**CITY OF CENTRAL POINT  
PLANNING COMMISSION AGENDA  
July 18, 2017 - 6:00 p.m.**

- A. Consideration of a Site Plan and Architectural Review application for Smith Crossing at Twin Creeks, a 245-unit multifamily development within the Medium Mix Residential (MMR) zone in the Twin Creeks TOD Master Plan area. The 9.45 acre project site consists of two (lots) on North Haskell Street identified on the Jackson County Assessor's Map as 37S 2W 03C Tax Lot 138 and 37S 2W 03DC Tax Lot 3400. Applicant: PCMI, Inc.; Agent: Scott Sinner, Scott Sinner Consulting, Inc.

**City of Central Point  
Planning Commission Minutes  
June 6, 2017**

- A. Public Hearing to consider a Site Plan and Architectural Review application for Smith Crossing at Twin Creeks, a 245-unit multifamily development within the Medium Mix Residential (MMR) zone in the Twin Creeks TOD Master Plan area. The 9.45 acre project site consists of two (lots) on North Haskell Street identified on the Jackson County Assessor's Map as 37S2W03C Tax Lot 138, And 37S2W03DC Tax Lot 3400. Applicant: PCMI, Inc.; Agent: Scott Sinner, Scott Sinner Consulting, Inc.**

LANDSCAPE PLAN L-1

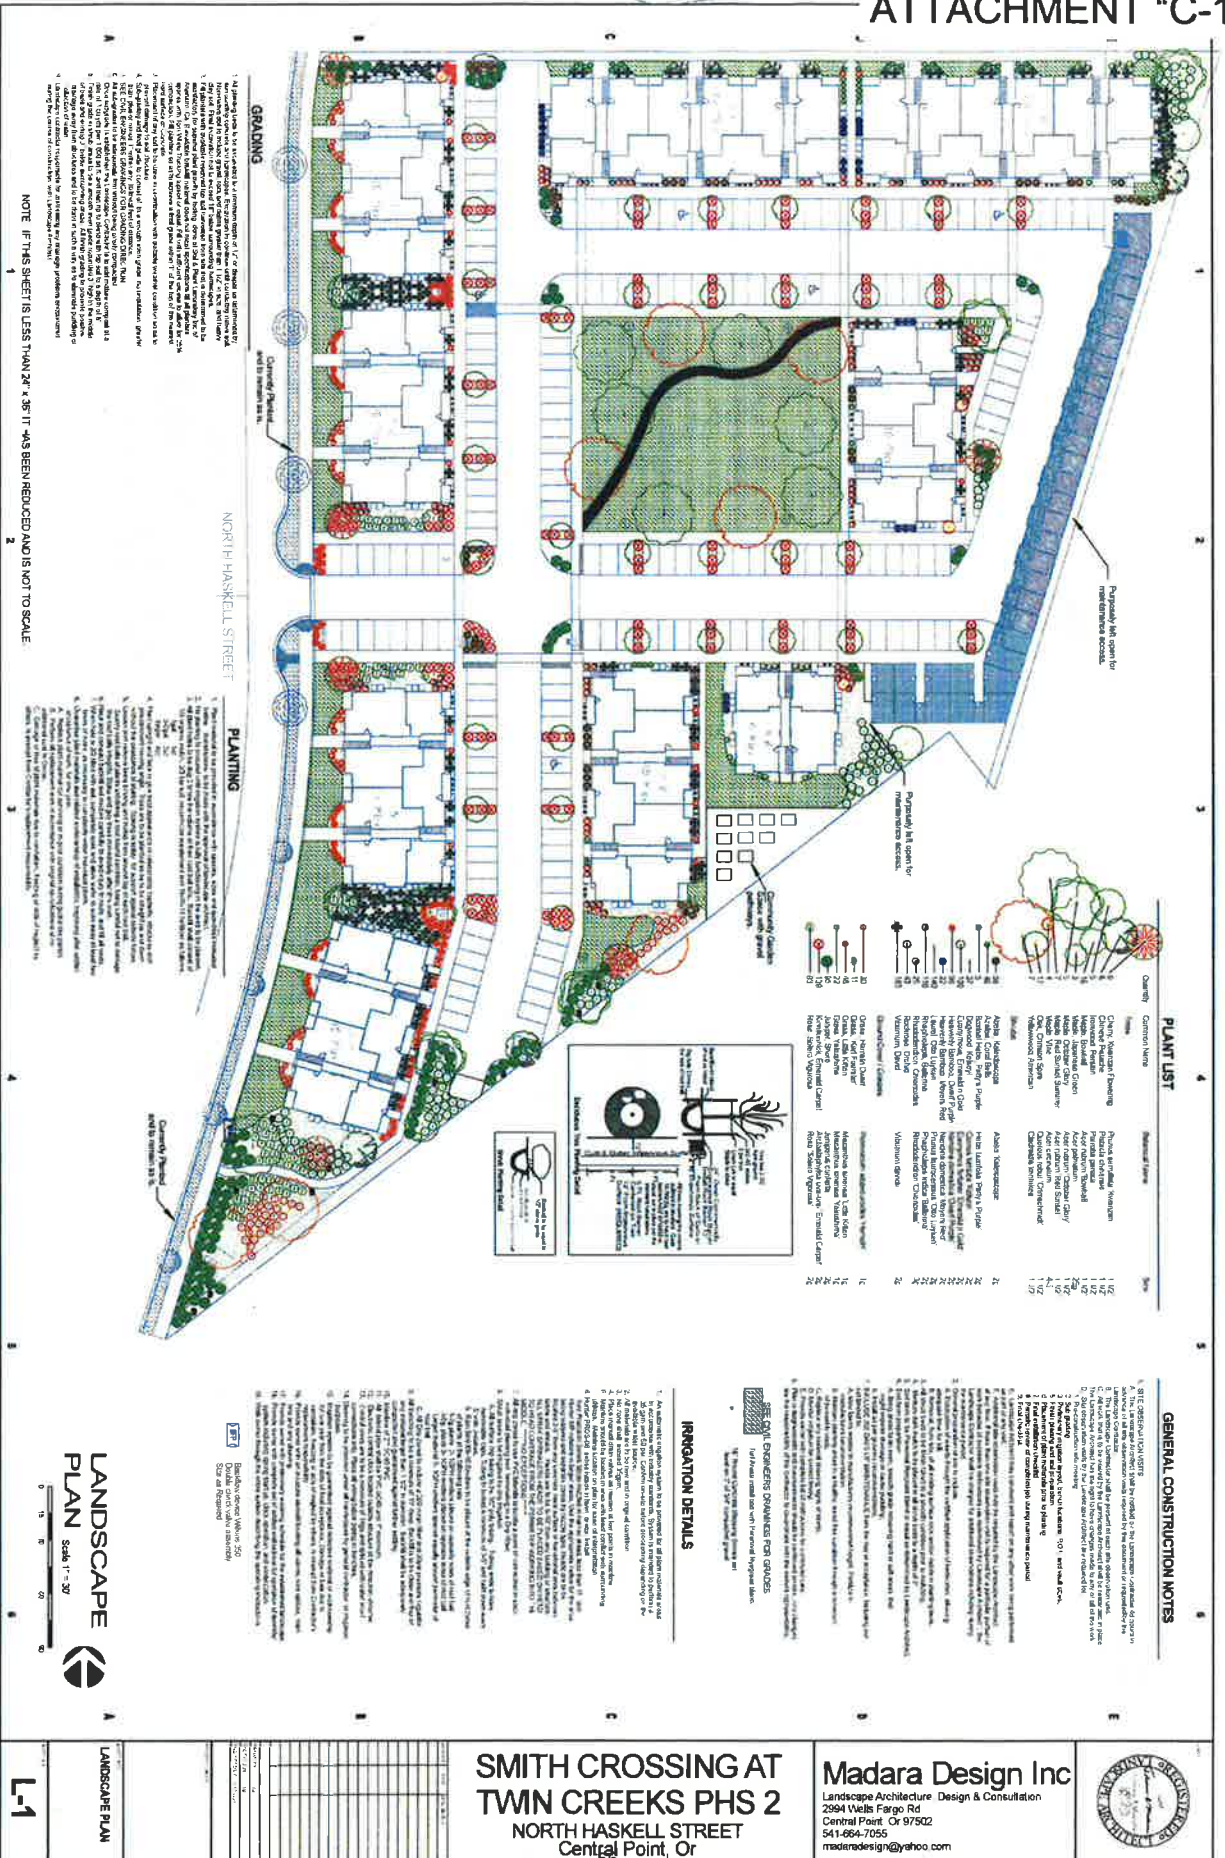
5. **Landscaping.** The Applicant's Landscape Plan does not provide adequate tree placement at the north entrance to Phase 1 as required in CPMC 17.67.050(K)(2)(a). This section of the code requires tree placement at 30-ft on center. Phases 1 and 2 do not provide adequate screening at the parking lot driveway entrances from North Haskell Street. CPMC 17.67.050(K)(2)(b) requires screening evergreen hedges or decorative fences walls or transparent screens.

There is sufficient area on the site to accommodate the required landscaping and screening per CPMC 17.67.050(K)(2)(a-b). Staff recommends that the Planning Commission impose Condition No. 5 to require submittal of a revised landscape plan at the time of building permit issuance.

Exhibit 3, Circulation Plan Detail

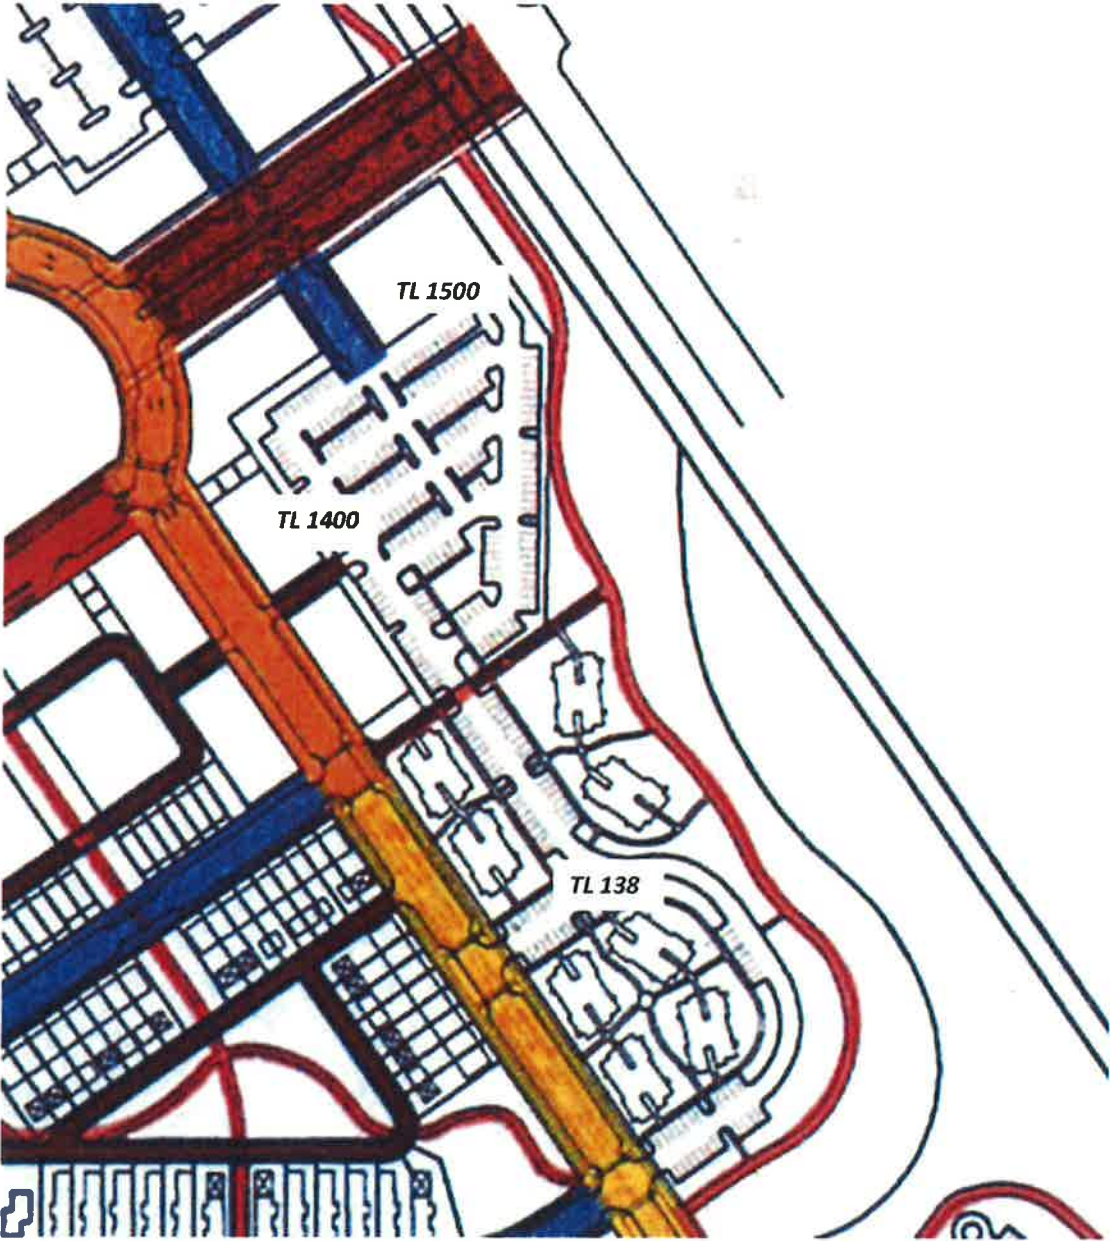
**Finding: Master Plan Exhibit 3, Circulation:** There is *"an opportunity to relocate (a) portion of"* a 65 foot section of the Off-Street Pedestrian Accessway. Regarding **Finding 17.67.040 (A) (9)**, *"the Applicant shall coordinate with Twin Creeks Development Co. to locate a portion of the path...."* Has that been done?

4. **Minor Pedestrian Accessway.** Phase 1 proposes a minor pedestrian accessway required per Master Plan, Exhibit 3. There is a 65-ft segment at the northeast property corner that does not provide the required 24” landscape row between the drive and the pathway per the standard identified in Master Plan Exhibit 12 (Attachment “B”).

4. Prior to building permit issuance for any building in Phase 1, the Applicant shall provide a written authorization to locate a portion of the Minor Pedestrian Accessway identified in the Twin Creeks Master Plan, Exhibit 3 on the adjacent open space tract, as necessary to comply with the Minor Pedestrian Accessway standard in Master Plan Exhibit 12.

Figure 2 – Master Plan Exhibit 3

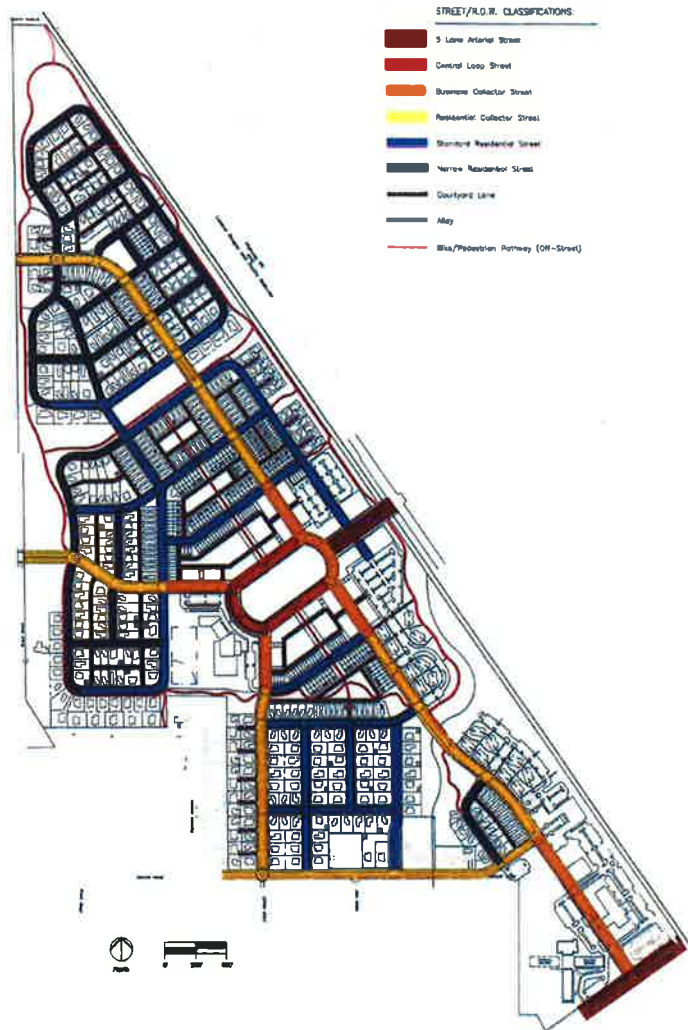
- 2) *Off-Street Pedestrian Accessways. An off-street pedestrian accessway is identified on Exhibit 3 (Figure 2) providing connectivity between North Haskell Street and Twin Creeks Crossing along the Griffin Creek open space corridor for public purposes. As illustrated on the Applicant's Site Plan for Phase 1 (Figure 5), a Minor Pedestrian Accessway is proposed along the project site perimeter from North Haskell Street to the northeast property boundary. The proposed design complies with the Minor Pedestrian Off-Street Accessway Cross Section identified as Exhibit 12 in the Master Plan with the exception of a 65-ft section at the north east property corner. Since the Master Plan doesn't indicate whether the pedestrian accessway is to be located on the project site or the adjacent open space lot, there is an opportunity to relocate this portion of the pathway on the adjoining open space lot and provide the required cross section. As conditioned, the Applicant is required to provide written authorization and a revised site plan demonstrating compliance with the Minor Pedestrian Accessway standard per the Master Plan prior to building permit issuance (Condition No. 4). -As conditioned, the Project can comply with Master Plan Exhibits 3 and 12.*

- 3) *Phase 1 Shared Access. Exhibit 3 illustrates an internal connection via a private drive between Phase 1 and the adjoining properties to the north (Figure 3). The private connection illustrated appears to be for open access, but the Master Plan does not provide clear instruction relative to internal circulation. The Applicant's Site Plan (Exhibit 1) illustrates a private connection at the northeast property corner as required. However, since the property to the northeast (37S 2W 03CA Tax Lot 1500) is planned for Employment Commercial use the Applicant has requested the shared connection be for emergency vehicle use only. The Applicant's request is to eliminate potential safety conflicts between the multifamily community and off-site traffic generated by a future commercial use. The owner of the Tax Lot 1500 has provided a letter of support for this request. Based on the lack of clarity offered by the Master Plan and support offered by the affected property owner, the City agrees that the Master Plan allows for the access restriction to protect public safety from the conflicts between a potential high-impact commercial use and medium density multifamily housing.*

**Conclusion Master Plan Exhibit 3, Circulation:** Based on an evaluation of the site plan for both phases (Exhibits 1 and 2), the proposed Project complies with Exhibit 3, Circulation relative to streets, off-street pedestrian access (as conditioned) and shared access as conditioned.
